PIC16C923 Rev. A Silicon Errata Sheet

The PIC16C923 (Rev. A) parts you have received conform functionally to the Device Data Sheet (DS30444D), except for the anomalies described below.

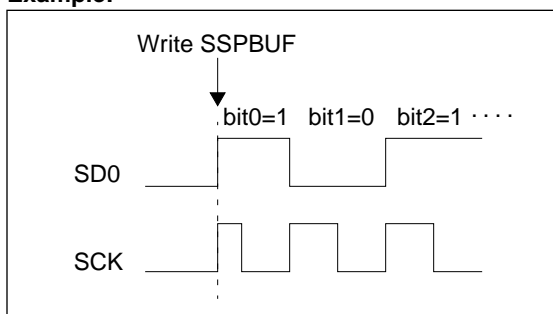
The Synchronous Serial Port module in SPI Master mode only allows the transmission of 1 byte of data at a time. The module must be disabled and then re-enabled between each byte transmission.

Once the SSP module has been configured in SPI Master mode and one byte of data has been transmitted, wait for the interrupt flag bit SSPIF (PIR1<3>) or BF(SSPSTAT<0>) to be set. This indicates that the byte of data has been transmitted. Then, disable the SSP by clearing the SSPEN bit of the SSPCON register. Re-enable the SSP by setting the SSPEN bit. The SPI module will now transmit the next data byte written to SSPBUF.

Example Code:

FIGURE 1: WRITES TO TIMER1 (EXTERNAL CLOCK / OSCILLATOR MODE)

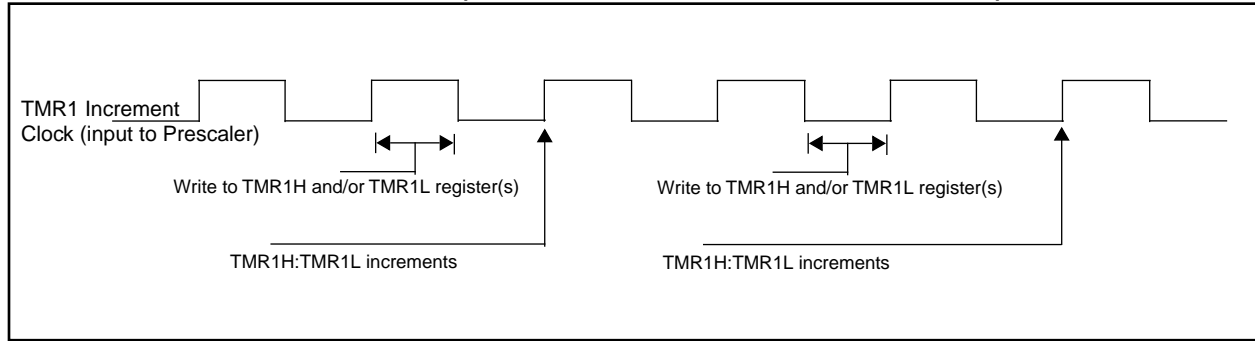
- a) The operation of Timer1 needs some clarification when the timer registers are written when the TMR1ON bit is set.

The internal clock signal that is the input to the TMR1 prescaler affects the incrementing of Timer1 (TMR1H:TMR1L registers and the Timer1 prescaler). When the Timer1 registers are NOT written, the Timer1 will increment on the rising edge of the TMR1 increment clock.

When the TMR1H and/or TMR1L registers are written while this clock is high, TMR1 will increment on the next rising edge of this clock.

When the TMR1H and/or TMR1L registers are written while this clock is low, TMR1 will not increment on the next rising edge of this clock, but must first have a falling clock and then the rising clock for TMR1 to increment.

Figure 1 shows the two cases of writes to the TMR1H and/or TMR1L registers. Due to the V_{IH} and V_{IL} thresholds on the oscillator/clock pins, external Timer1 oscillator components, and external clock frequency, the Timer1 increment clock may not be of a 50% duty cycle.

The TMR1 increment clock is out of phase of the T1OSO/T1CKI pin by a small propagation delay.
